SR-2 – ADVISORY STAFF REPORT (03-06-2026)

ADDRESS: 15112 ROSEMONT

APPLICATION NUMBER: HDC2026-00062

SCOPE: REPLACE WOOD WINDOWS WITH VINYL WINDOWS (WORK DONE WITHOUT APPROVAL)

Record photo, 2002

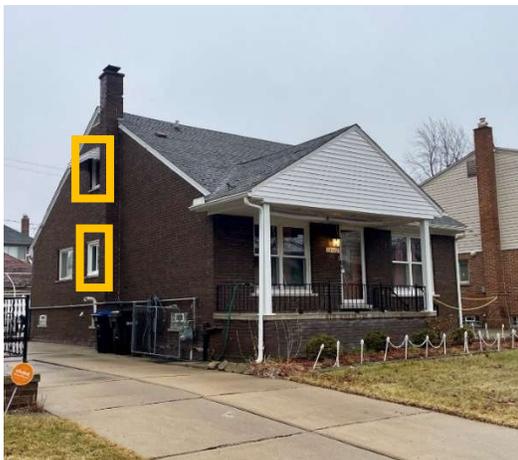
- The Period of Significance for the Rosedale Park Historic District is 1917 through 1955. Since the dwelling was built in 1965, ten years outside of the period of significance, it is considered a non-contributing resource. Replacement windows must be in accordance with the NPS guidance provided in the document [“Replacement Windows that Meet the Standards,”](#) which states “Replacement of ...non-historic windows must, however, always fill the original window openings and must be compatible with the overall historic character of the building.”
- Vinyl (i.e. PVC) windows were first introduced for residential use in the United States in 1964. While the first PVC windows were developed in Germany in the mid-1950s, they did not appear in the U.S. market until the mid-1960s, gaining popularity in the 1970’s as an inexpensive alternative to wood and metal.

Photo from application

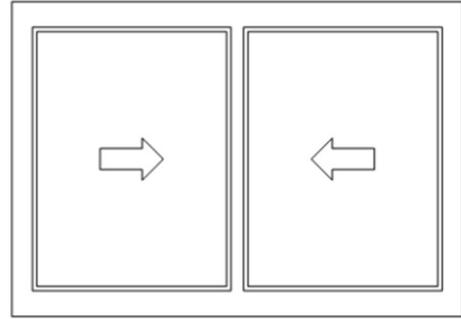
PROPOSED

Vinyl, double slider, white in color

- Per the Elements of Design (Sec. 21-2-199) (excerpts from staff):
 - **(7) Relationship of Materials:** *Windows are commonly either of the metal casement or wooden sash variety. Aluminum siding and aluminum canted windows on later buildings are sometimes original; vinyl siding and vinyl windows, where they exist, are replacements.*
 - **(10) Relationship of architectural details:** *Contributing residential buildings, constructed between 1917 and 1955, were designed in styles identified as English Tudor Revival, Arts-and-Crafts, Bungalow, Colonial Revival, Dutch Colonial Revival, Foursquare, Prairie, French Renaissance, Ranch, Garrison Colonial, Minimal Traditional, and International, or hybrids of these styles.*
